Auckland Surf Park Community Resource Consent Decisions

Stage 1 Fast-Track Approval (BUN60429155)

**RECORD OF DECISION OF THE EXPERT CONSENTING PANEL
UNDER CLAUSE 37 SCHEDULE 6 OF THE COVID-19 RECOVERY
(FAST-TRACK CONSENTING) ACT 2020**

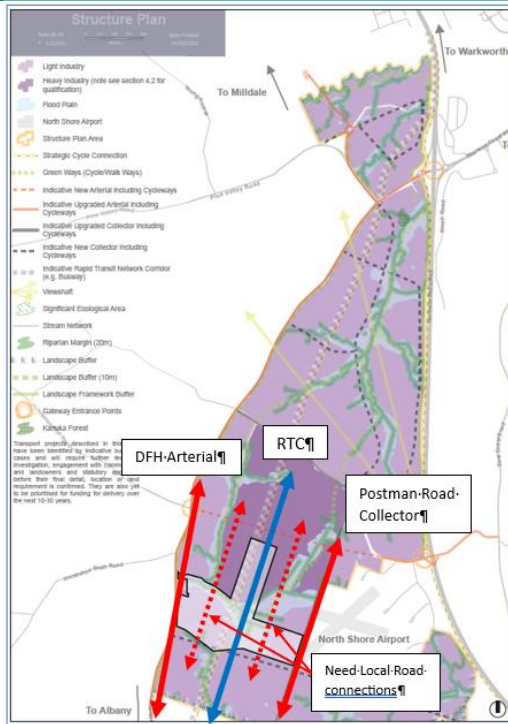
2.9	In my view, the most significant issue is that aspects of the proposal could compromise the future urban development of the adjoining land for industrial activity (Policy 6(e)). Reverse sensitivity effects could arise for adjoining industrial uses from the accommodation and wellness retreat components with pressure on industrial activity to reduce effects that are a normal part of an industrial area. Also, the visitor accommodation and wellness retreat could be vulnerable to effects from the adjoining industry eg noise, odours etc. I note that visitor accommodation is not provided for in the Heavy or Light Industrial Zones, the likely future zoning of the area as identified in the Structure Plan. I acknowledge that it is provided for in the Future Urban Zone as a Discretionary Activity.	We disagree with their assessment. This matter has been addressed within the Planning Memo accompanying this response as Attachment 1 .

2.10	The proposed surf park development could also compromise the future development of an interconnected local roading network and integration with adjoining industrial land to the north and south (see Figure 3). This is addressed in Policy 6(b). As the site and the development extend from Dairy Flat Highway through to the Postman Road it effectively severs the industrial area into a northern area and a southern area.	We disagree with their assessment. This matter is addressed in the Transportation Memo accompanying this response as Attachment 6 .

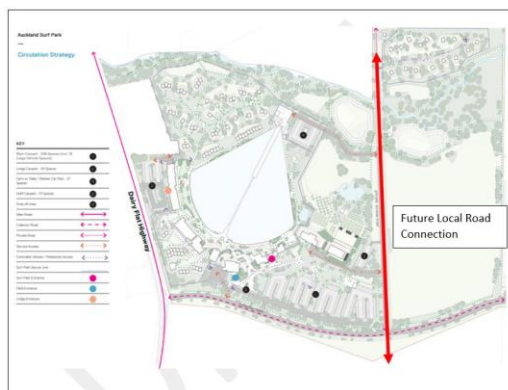
2.11 The applicants plan shows a private road connection to the east of the surf park. As a private road this does not enable permeability and north south connections and forces internal traffic to the north and south onto Postman Road (collector) or Dairy Flat Highway (arterial). It therefore prevents the development of a public local road network being constructed between the adjoining industrial areas to the north and south. In my view it is very important that the private road corridor is wide enough to accommodate a future local road connection and walking and cycling between the industrial areas to the north and south of the surf park (see Figure 4).

2.12 The proposal acknowledges the proposed Rapid Transit Designation through the site. In my view consideration also needs to be given to local road connection to the east of the RTC

We disagree with their assessment. The Transportation Memo accompanying this response as **Attachment 6**, and the Future Contextual Analysis Masterplan included as **Appendix 52** confirm that a through connection can be achieved.

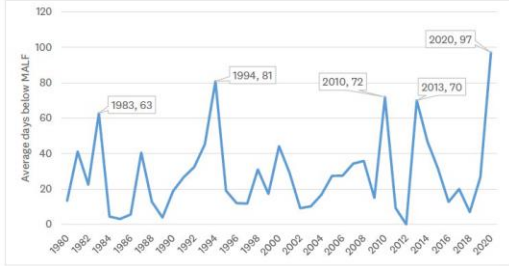
4.3	For the proposed take site on Tributary no. 078737 subject of the application (See blue star site in Figure 2 of this Memo) the Specialist has calculated the MALF as 0.86 l/s for the 2.2 km ² catchment area (40% greater than the value in the AEE Appendix 20 report), based on the 7-day mean annual low flow specific discharge for the AC Rangitopuni Stream flow site of 0.39 l/s/km ² .	This matter is addressed in the Wetland and Hydric Soil and Hydrology Memo accompanying this response as Attachment 10 .

4.4	The effects of taking such a potential high proportion of stream flow runs the risk of the stream flow being "Flat-lined". Effects of the proposed take on stream habitat space and water quality were not investigated as part of the AEE.	This matter is addressed in the Wetland and Hydric Soil and Hydrology Memo accompanying this response as Attachment 10 .

4.5	In addition, relying on a stream take to maintain the Surf Park lagoon is risky because stream flows will drop below the 7-day Mean annual low flow in some years. Figure 4 of this Memo is a graph of "Regional average days of stream flow below the MALF" from a Council report "Hydrologic Effects of the 2020 Drought on Auckland Regional Waterbodies", Discussion Paper DP2021/2, December 2021 by Kolt Johnson. It shows that the stream take	This matter is addressed in the Wetland and Hydric Soil and Hydrology Memo accompanying this response as Attachment 10 .
